[Darshan_04_0917.pdf](#) (PSE state machine Part A- Using CLASS_PROBE in Figure 145-15/16)
Comment (i-198, i-269, i-406)

4. Make the following changes to the state machine in page 132 Figure 145-15:

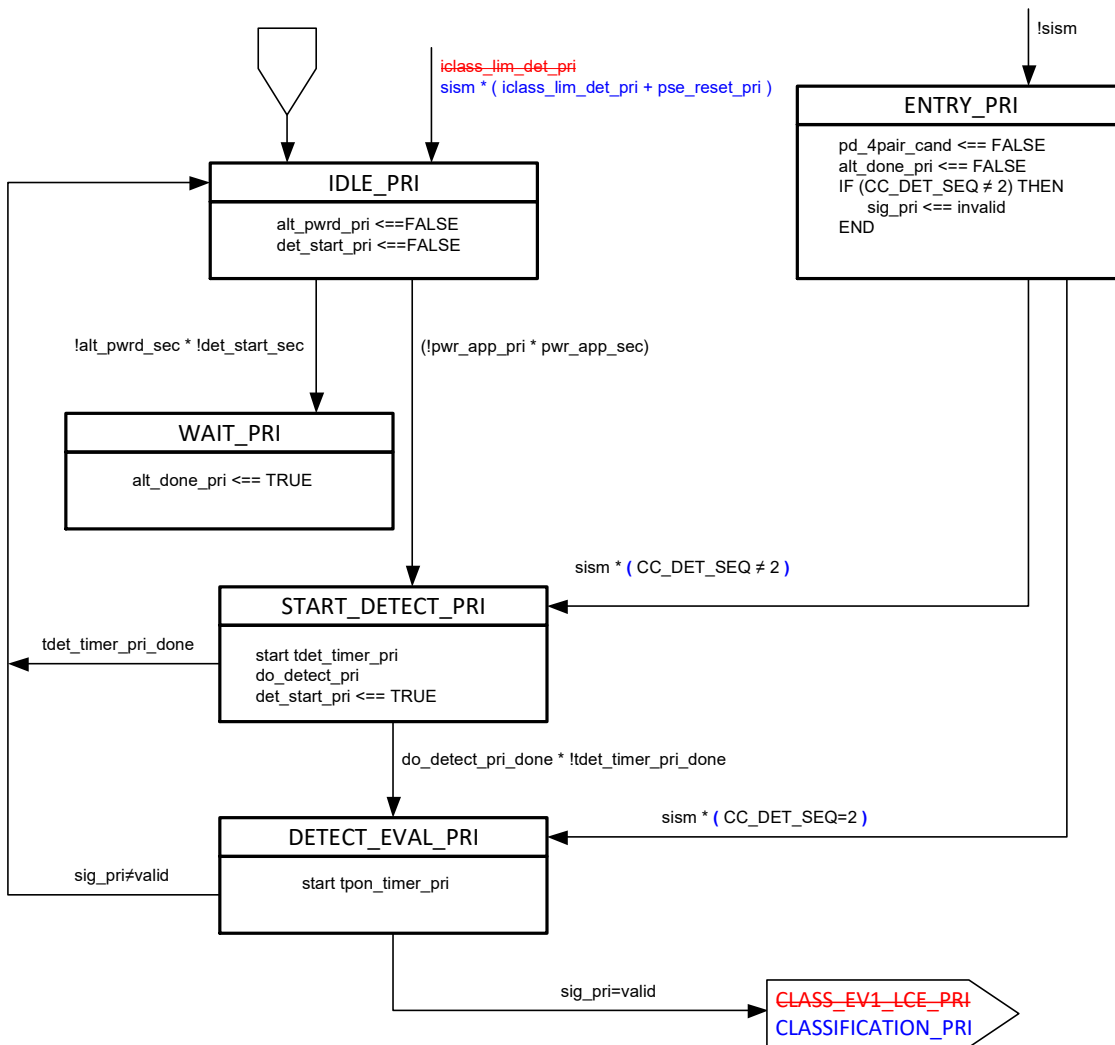
Global pse_reset_pri was inserted in the same way we did for single-signature.

The variable sism was added as a condition for both iclass_lim_det_pri and pse_reset_pri. From logical operation point of view, sism is not required as a condition for iclass_lim_det_pri since iclass_lim_det_pri = TRUE only if we have do_classification_pri which can happen only if sism=TRUE, however we keep it as proposed for now until confirmation from simulation.

Figure 145-15—Primary Alternative dual-signature semi-independent PSE state diagram (continued)

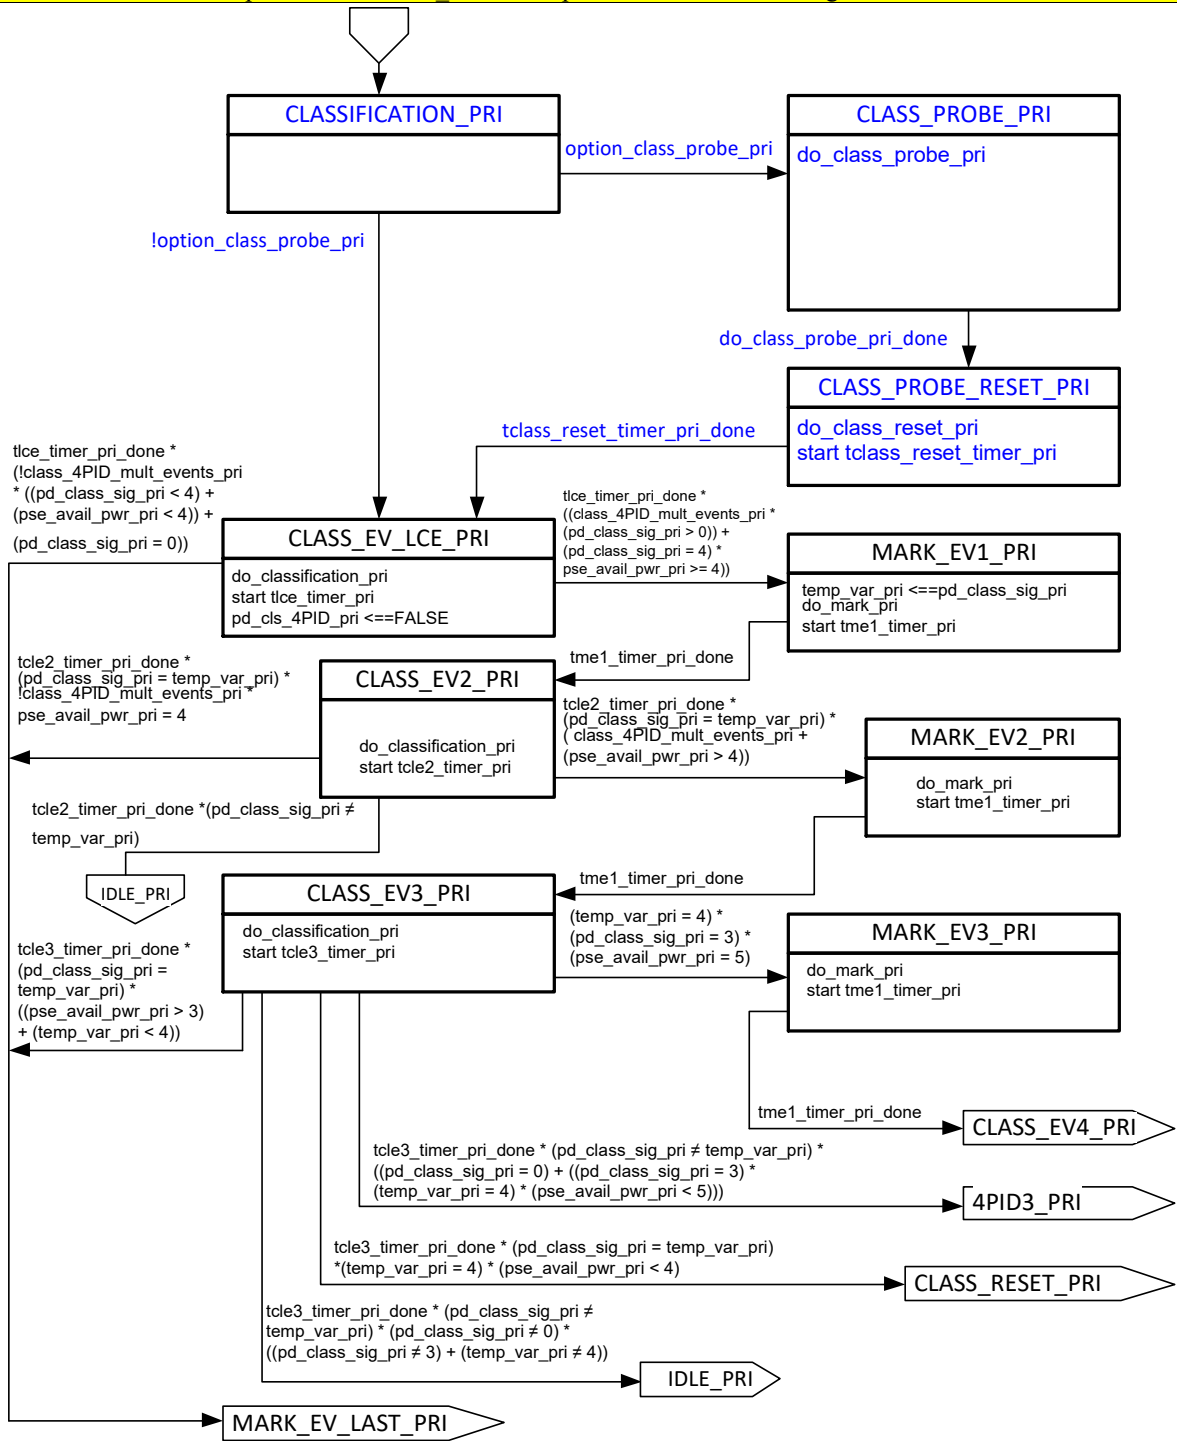
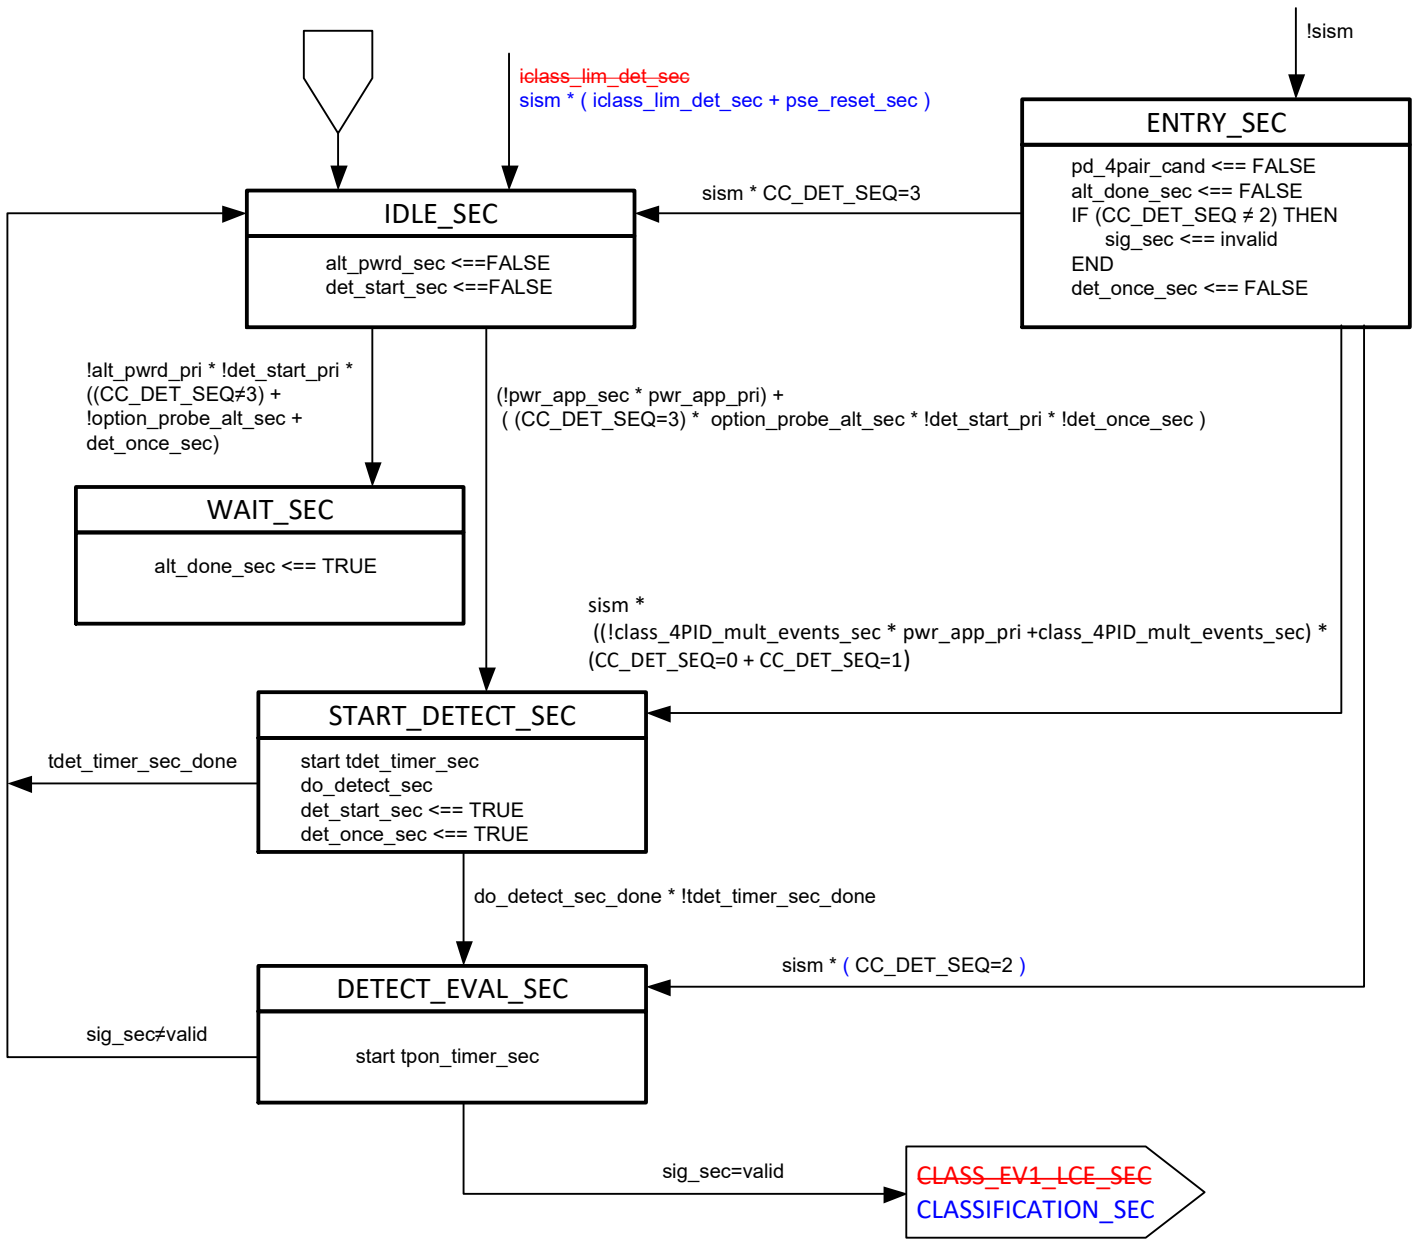
5. Make the following changes to Figure 145-15 page 133

We had a discussion if we need explicit exit to IDLE_PRI with optional variable. We thought we don't need it. See Annex A for details.

Figure 145-15—Primary Alternative dual-signature semi-independent PSE state diagram (continued)

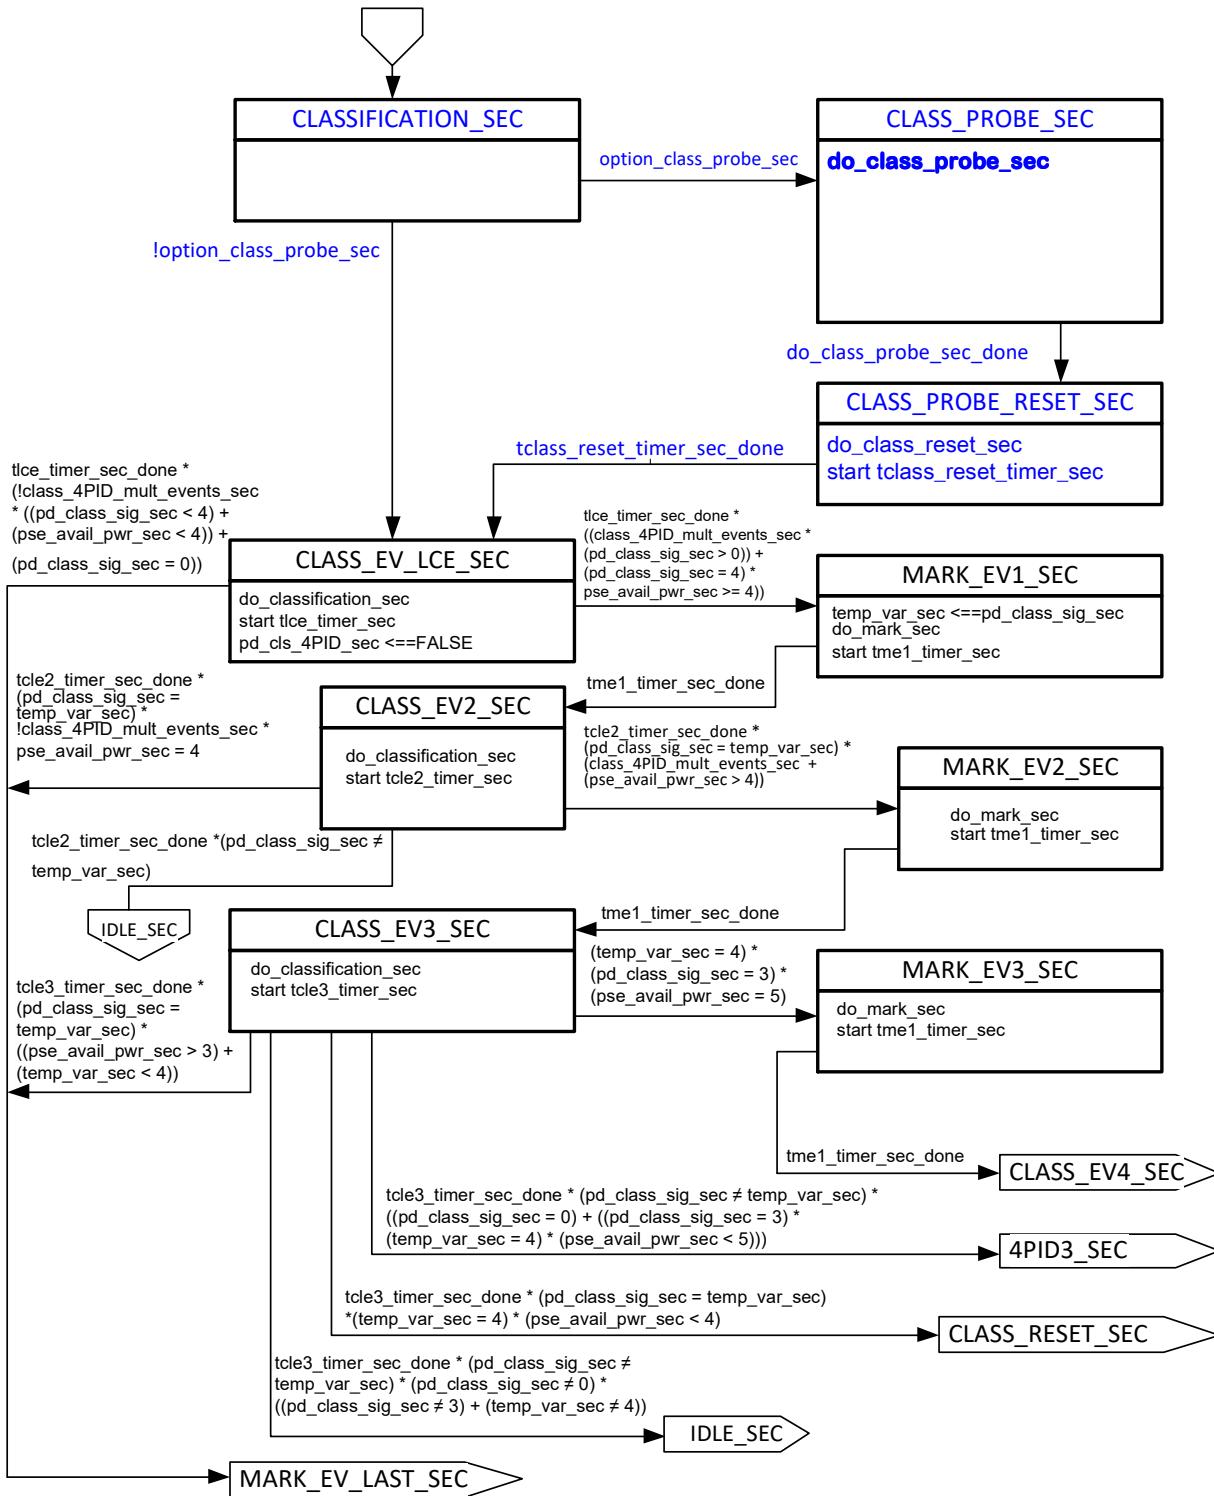
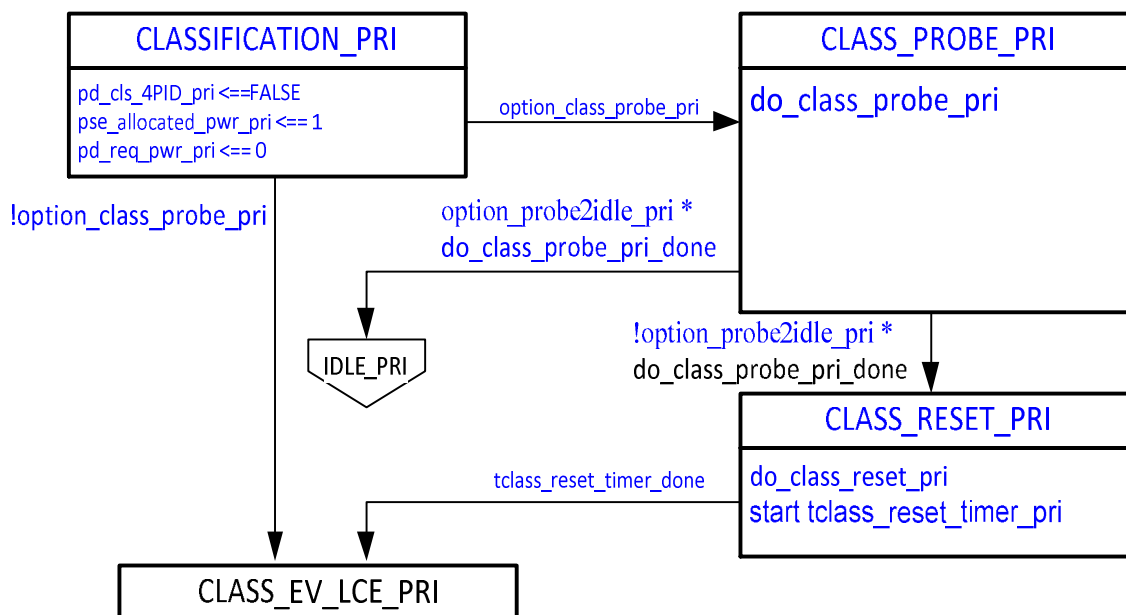
6. Make the following changes to the state machine in page 136 Figure 145-16:

7. Make the following changes to Figure 145-15 pages 137:
